# Late Correspondence

- Letters from neighbors of 2245 Liberata Drive, Morgan Hill (APN 728-24-008), on proposed development.

**From:** [REDACTED]  
**To:** [Tran, Lara](#)  
**Cc:** [Eastwood, Rob](#); [Hoem, Christopher](#)  
**Subject:** [EXTERNAL] Staff Report  
**Date:** Saturday, January 30, 2021 6:22:28 PM

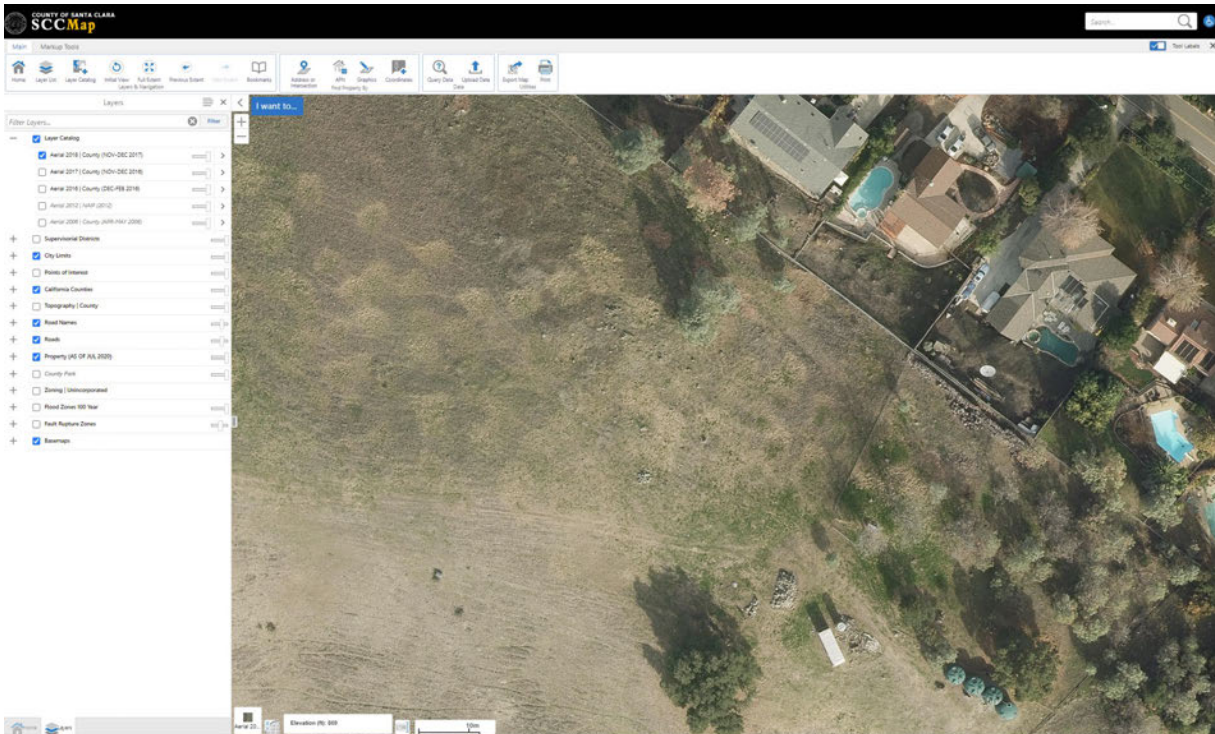
And here are a couple photos of the previous grading. There were multiple times the bulldozer came:

I am very concerned that this problem will get worse. As I said in previous notes, the impacts from the previous grading should be mitigated. The previously existing swale

should be restored so the water can drain. There used to be rock and concrete chunks down this swale to avoid erosion, but it was all buried.

Nov-Dec 2017

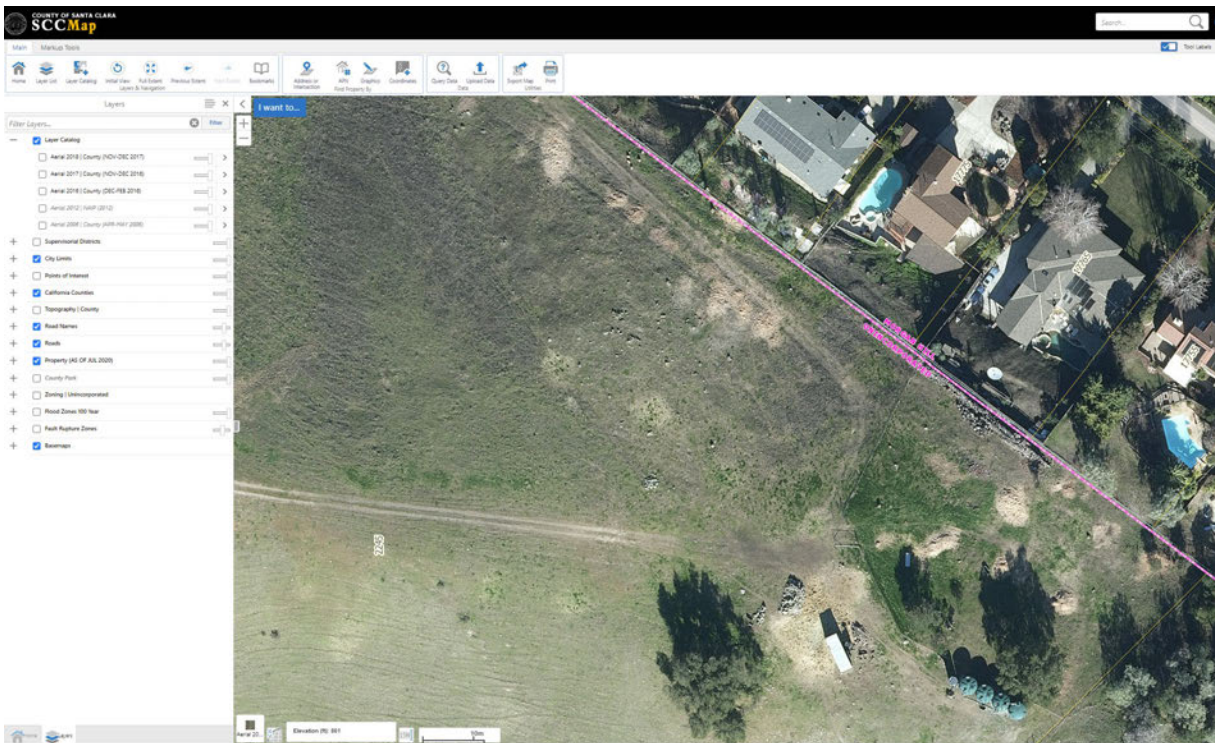
Notice all the trees in the corner of the lot near the water tanks, and a few trees behind the house with solar panels.

It appears many trees have already been removed. This has likely had an environmental impact. Is this compatible with an open space easement, particularly right near a ridgeline. If you go back to the 2006 survey, there are even more. Is it fair to claim no trees are being removed, when they were removed before the process started? I looked for this because I heard the chainsaws.
